19 August 2019

Pearl High School Multipurpose Building

## ADDENDUM NO. 01

**7**  
S3.1 ENLARGED PLAN AT SIDE EXIT  
1/4" = 1'-0"

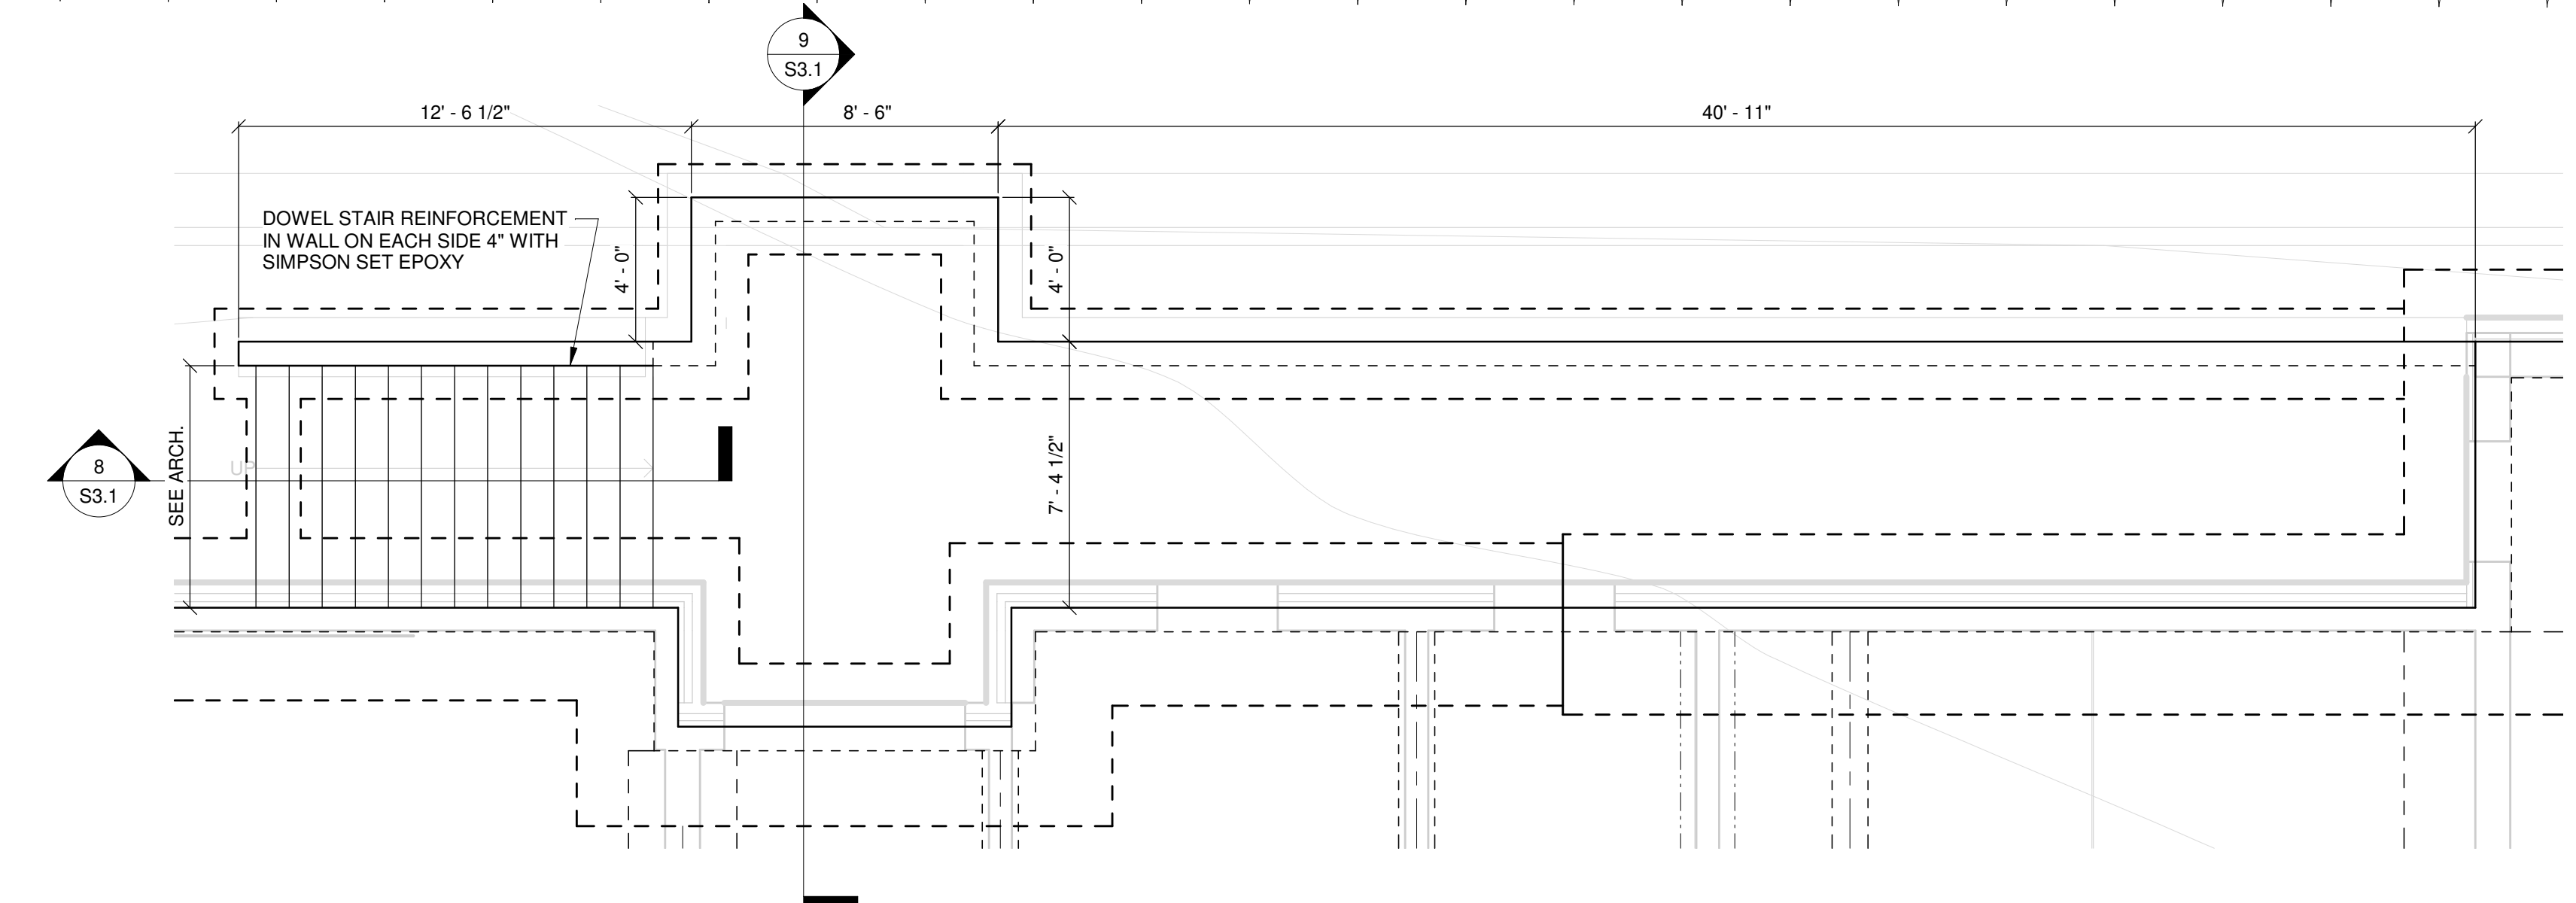
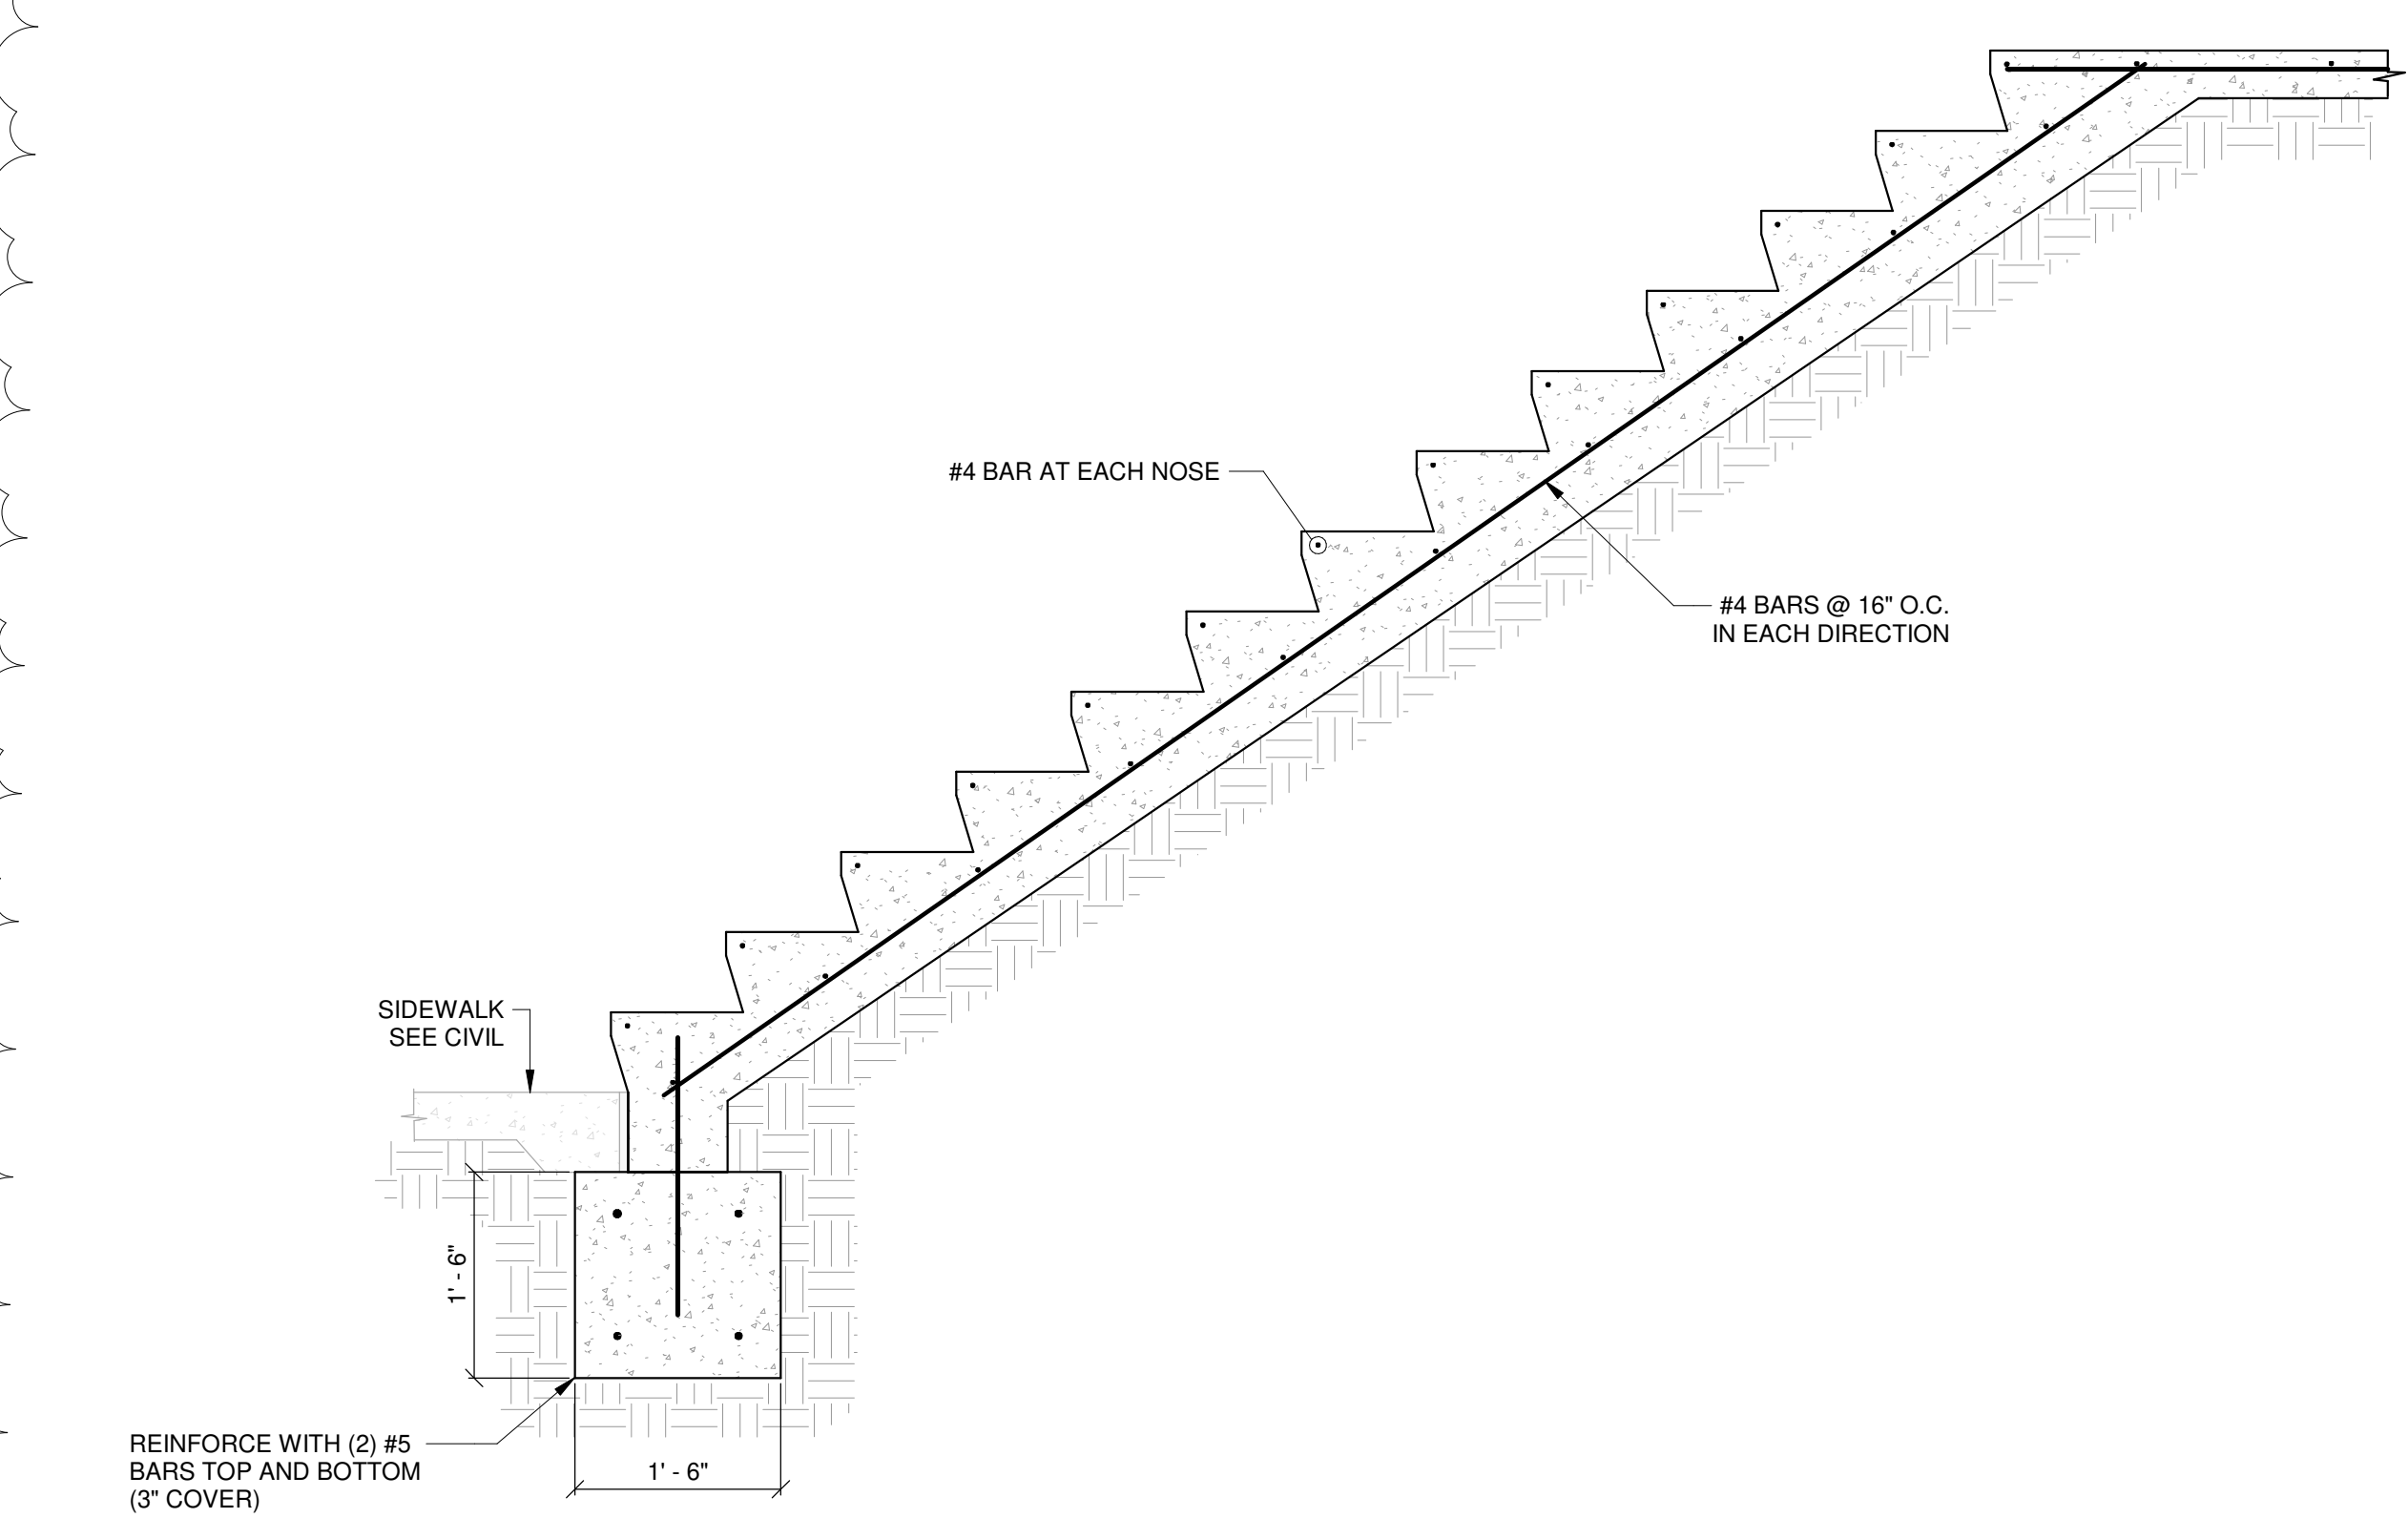
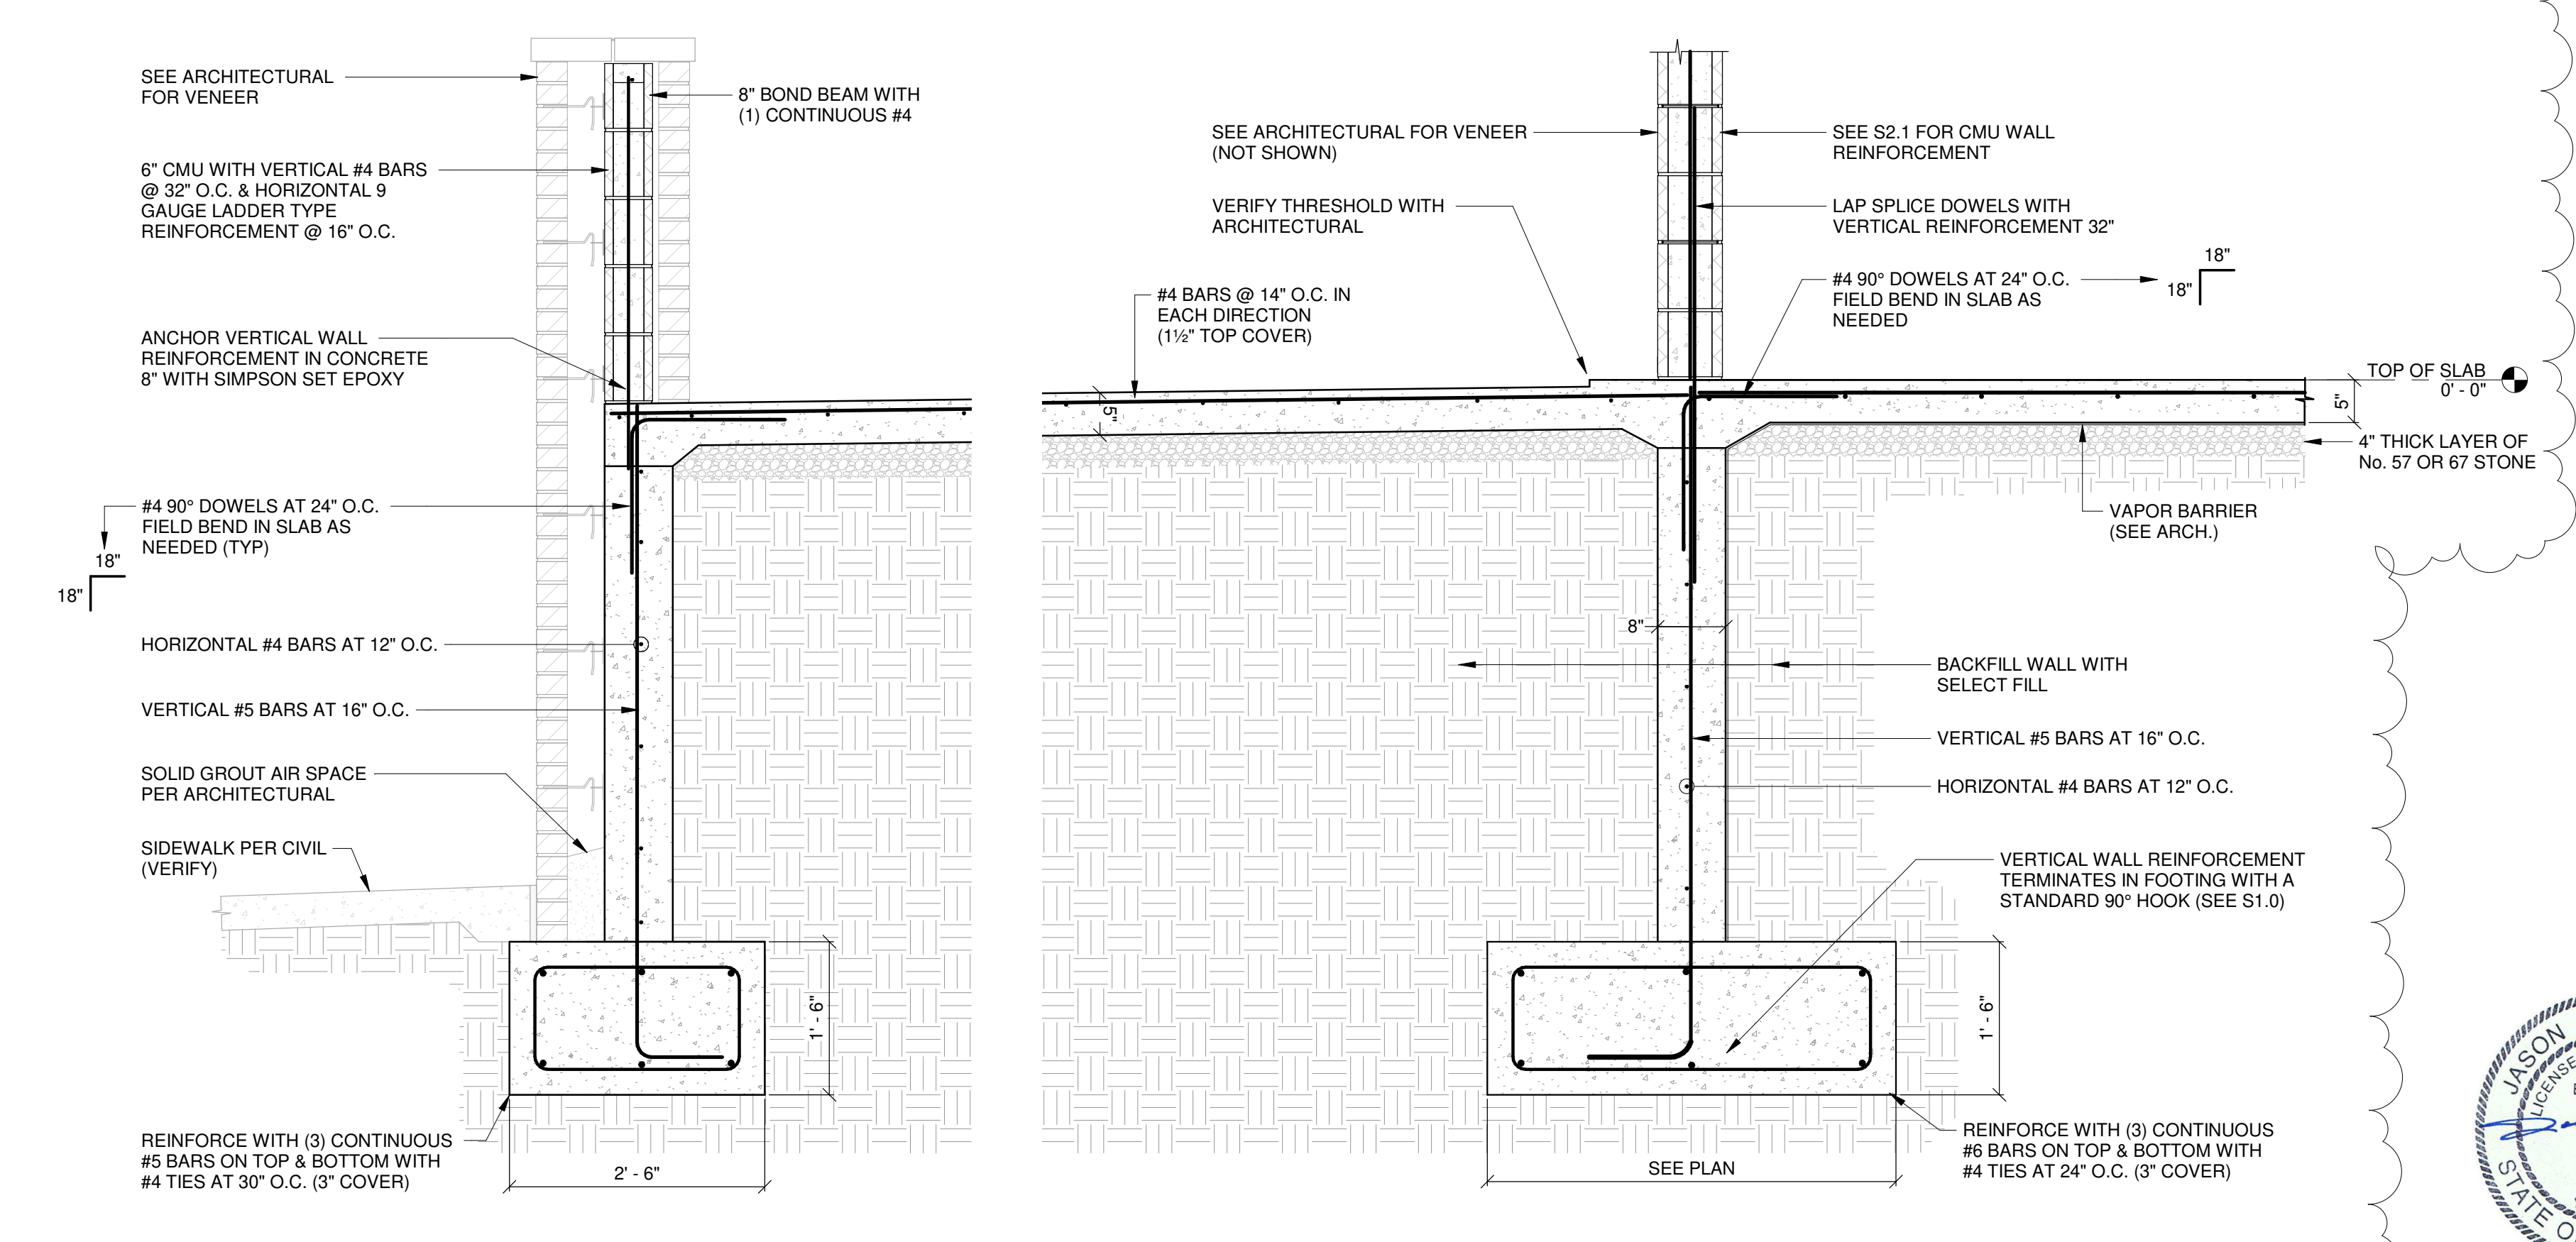
- ITEM NO. 58**      **SHEET S3.0 DETAILS**  
*REPLACE* sheet with attached revised sheet **S3.0**.  
Revises details 4 & 5.  
Adds detail 6.
- ITEM NO. 59**      **SHEET S3.1 DETAILS**  
*REPLACE* sheet with attached revised sheet **S3.1**.  
Adds details 7, 8, & 9.

**1** ROOF JOIST BEARING AT INTERIOR WALL  
S3.2 3/4" = 1'-0"

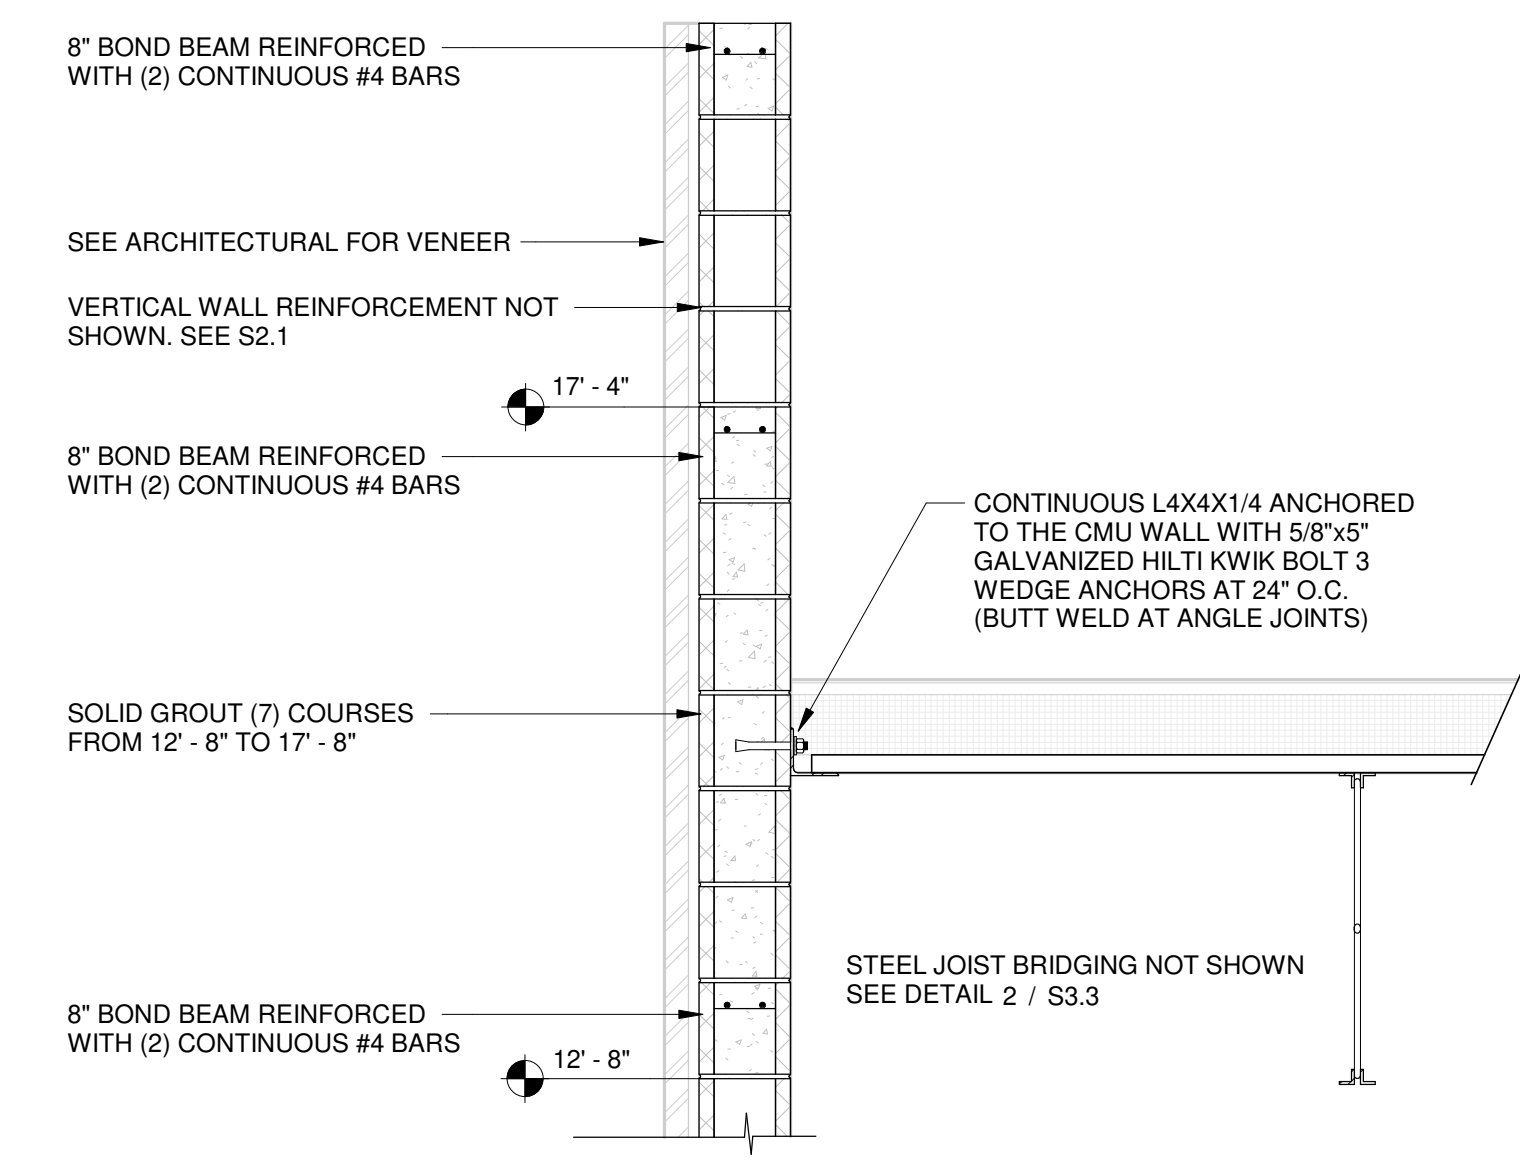
- ITEM NO. 60**      **SHEET S3.2 DETAILS**  
*REPLACE* sheet with attached revised sheet **S2.3**.  
Adds details 1 & 2.
- ITEM NO. 61**      **SHEET S3.3 DETAILS**  
*REPLACE* sheet with attached revised sheet **S3.3**.  
Adds details 4 & 5.
